Re: Approval of the Preliminary Plat of Venwoods Estates 4th Addition, a proposed 6 lot residential subdivision in SW¹/₄ of the SE¹/₄ of Section 6 and NW¹/₄ of the NE¹/₄ of Section 7 all in Pleasant Valley Township.

PLANNING & ZONING COMMISSION
STAFF REPORT
August 15, 2017

Request: Preliminary Plat of Venwoods Estates 4th Addition

VENWOODS ESTATES FOURTH ADDITION

PROJECT: PRELIMINARY PLAT
VENWOODS ESTATES 4th ADDITION
BETTENDORF, IOWA

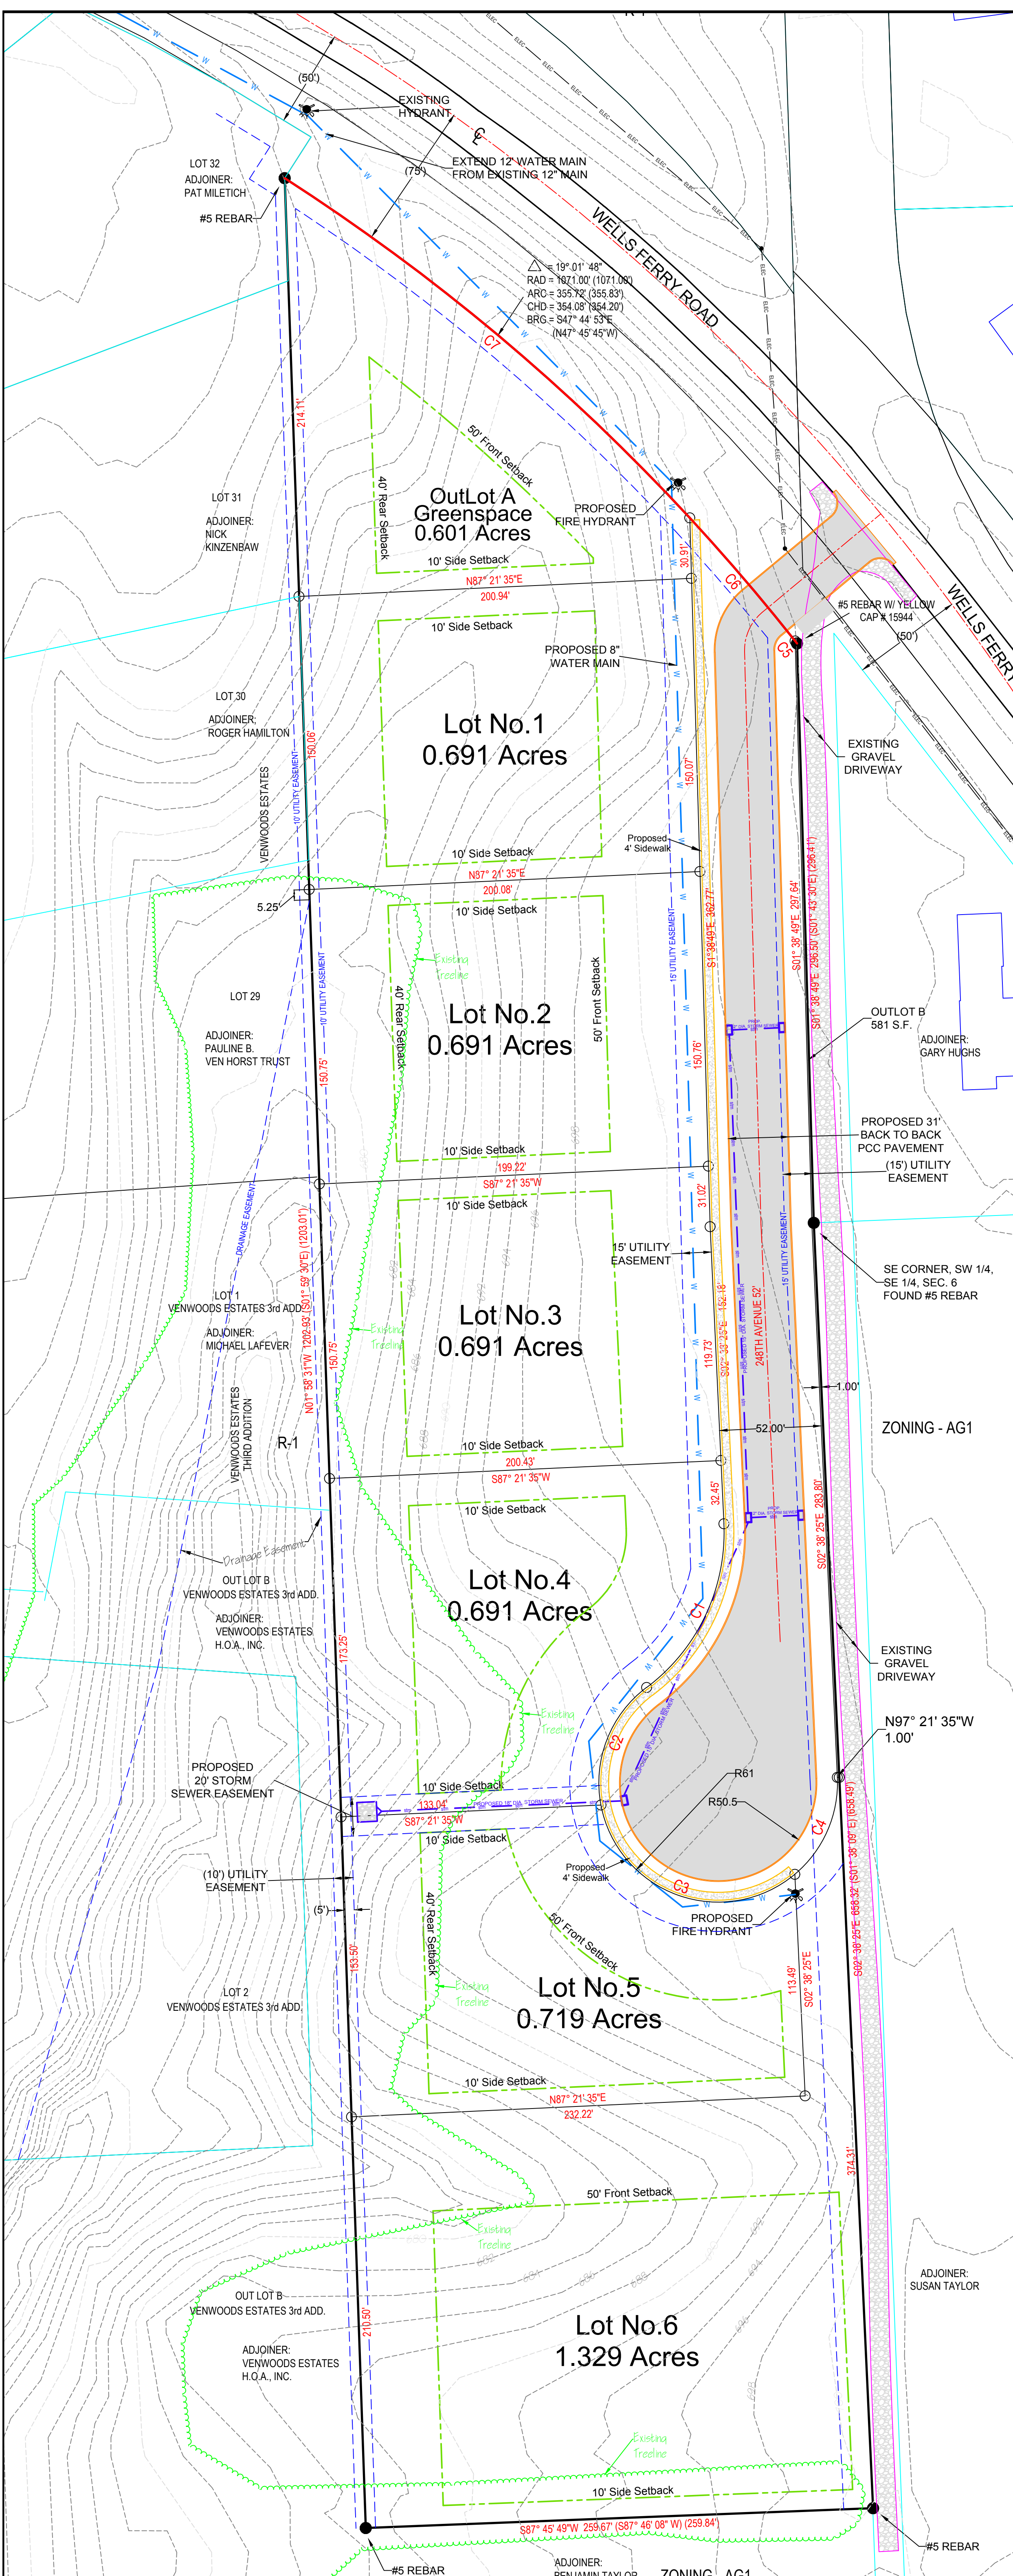
The proposed Preliminary Plat would utilize an underground storm sewer system with five (5) stormwater intake gutters along the roadway and a 20-foot storm sewer easement between Lot 4 and Lot 5 with a stormwater outlet on the west side of the property adjacent to Outlot B of Venwoods 3rd Addition.

A copy of the letter we received from the Venwoods Estates Homeowners Association stating their concerns relative to stormwater management is included with this staff report. Staff has requested documentation of the approval for this development to use Outlot B for stormwater generated from this property.

The original lot #36 was to have 1 single family dwelling on it, whereas the proposed replat will split this into 6 buildable lots and 1 outlot. The HOA is supportive of this replating, however, the concern we have has to do with the increased rapid storm water runoff due to the increased roofs, driveways, sidewalks and road into the existing detention pond located on outlot B owned by the HOA. There is already significant runoff going into the existing detention pond.

1. During the planning of this fourth addition was any analysis completed to determine the impact of going from one house to six houses upon the existing detention pond and its capacity?

2. The plat shows a storm sewer easement between lots 4 and 5. It appears that this storm sewer will empty directly onto Outlot B owned by the HOA and then flow down through Lot 2 of Venwoods 3rd addition before flowing down further into Outlot B and the detention pond. The HOA is concerned that the flow of water across this steep slope (~ 14 foot drop) will cause erosion of HOA land and the Lot 2 owners land. Was any consideration given to having the developer extend the drainage down to the bottom of the slope to minimize any potential erosion? Is some other method of erosion control going to be implemented?

3. On the preliminary plat document, under the notes, the following statement is made: "Storm Water Detention to be provided by Venwoods Estates 3rd Addition – Outlot B via drainage easement." The maintenance of this Outlot B detention pond is currently the responsibility of the Venwoods Estates HOA which had included lot 36. Whereas this replat of Lot 36 is being considered and that this replat will have 7 lots adjoining the drainage area which is equal to the number of lots to the west, the current Venwoods HOA would request that the developer and any future separate HOA of the fourth addition be equally responsible for the detention pond maintenance and upkeep.

1. That documentation be submitted of the approval for this development to use Outlot B of Venwoods Estates 3rd Addition for stormwater generated from this property;
2. The proposed wastewater treatment facilities meet Health Department requirements;
3. The private covenants include provision for private road and common open space maintenance;
4. The County Engineer review and approve all street construction plans prior to construction;
5. The subdivision infrastructure improvements be completed or a surety bond posted prior to Final Plat approval;
6. And that an erosion mitigation measure such as riprap be installed at the stormwater drainage outlet that exits West of Lots 4 and 5.

1. Documentation be submitted of the approval for this development to use Outlot B of Venwoods Estates 3rd Addition for stormwater generated from this property;
2. The proposed wastewater treatment facilities meet Health Department requirements;
3. The private covenants include provision for private road and common open space maintenance;
4. The County Engineer review and approve all street construction plans prior to construction; and
5. The subdivision infrastructure improvements be completed or a surety bond posted prior to Final Plat approval.
